Arup - Fire Consultant

Cambridge Civic Quarter

RIBA Stage 2 Fire Strategy Report - Guildhall

Drawing Title
Proposed Third Floor Plan

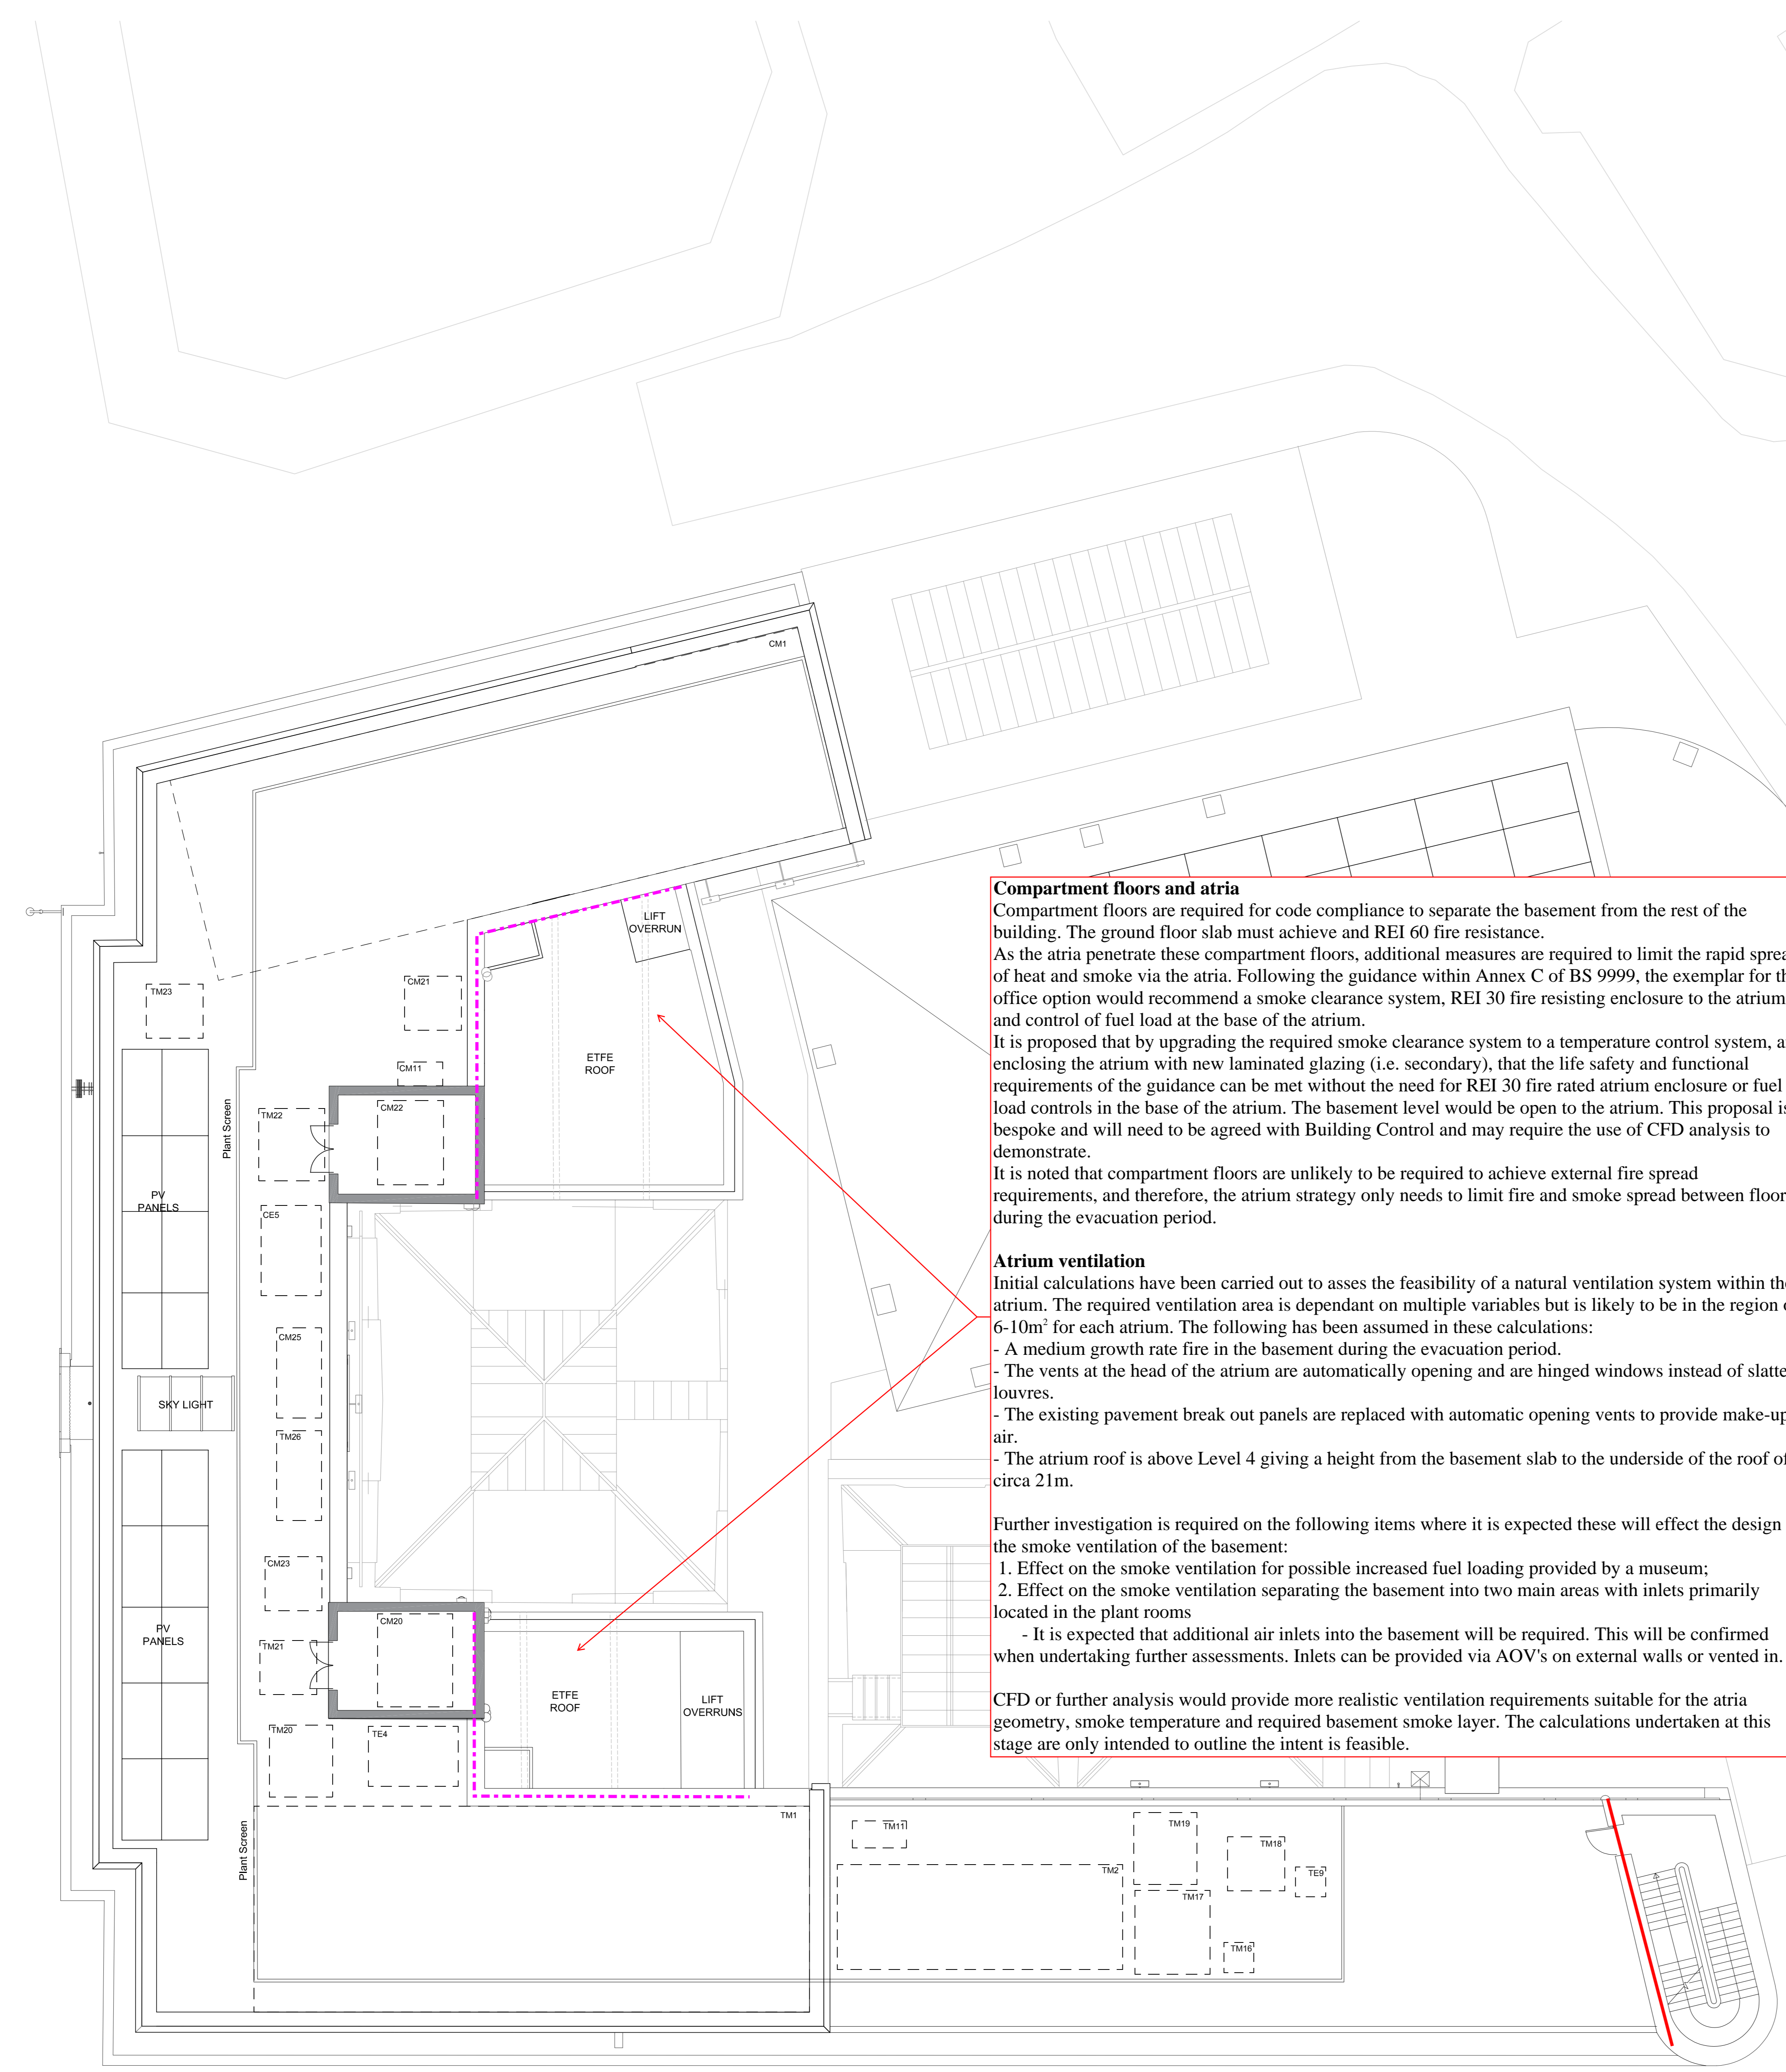
Further investigation is required on the following items where it is expected these will effect the design the smoke ventilation of the basement:
1. Effect on the smoke ventilation for possible increased fuel loading provided by a museum;
2. Effect on the smoke ventilation separating the basement into two main areas with inlets primarily located in the plant rooms
- It is expected that additional air inlets into the basement will be required. This will be confirmed when undertaking further assessments. Inlets can be provided via AOV's on external walls or vented in.

CFD or further analysis would provide more realistic ventilation requirements suitable for the atria geometry, smoke temperature and required basement smoke layer. The calculations undertaken at this stage are only intended to outline the intent is feasible.
